As follow up requested by the inspectors at the hearing on October 1st, please find below comments and information for Deadline 6 from myself on behalf of Bickenhill Village:

Plan of Current Taxi (& Airport Pickup) Parking Hotspots On or Adjacent To Catherine de Barnes Lane

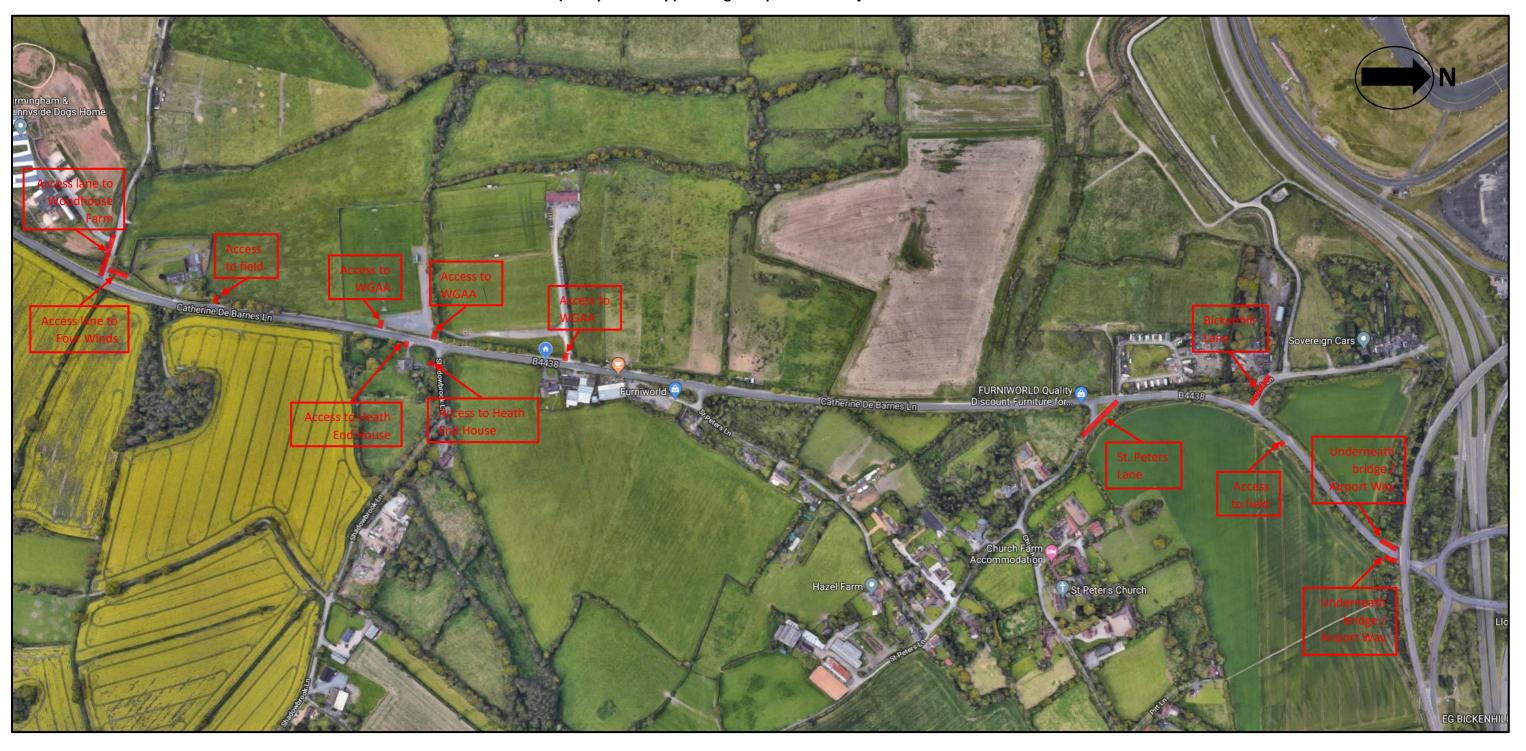
Thirdly as agreed we have investigated screening of the proposed main site compound from Bickenhill Village. Several villagers and I have walked the length of the village to identify hotspots where screening will be critical to avoid seeing right into the compound. We have drawn several conclusions based on marking 2m (the height of the topsoil stacks), and 3.6m (the maximum possible screening alluded to at the last hearing) on photographs at the Church Lane side at the top of the proposed compound field. Whilst this was not a rigorous scientific exercise it has allowed us to draw the following conclusions:

- Visual and acoustic screening will be required around the whole of the compound.
- There are areas where the 2m high topsoil stack might be sufficient- at the north end of Church Lane, depending on exactly how high up the slope the compound extends to.
- However at the view from Mr Cotterill and Mrs Burton's bedrooms 3.6m might not be sufficient, and certainly the view from the end of Pitt Lane would not be sufficient. The screening in this area will be most effective on the Church Lane side border of the main field-the further into the proposed main compound field the screening goes the less effective it will be due to the drop in elevation.
- We would also request further information from Highways England on what possible solutions might exist to address the pinchpoints where 3.6M might not be sufficient.
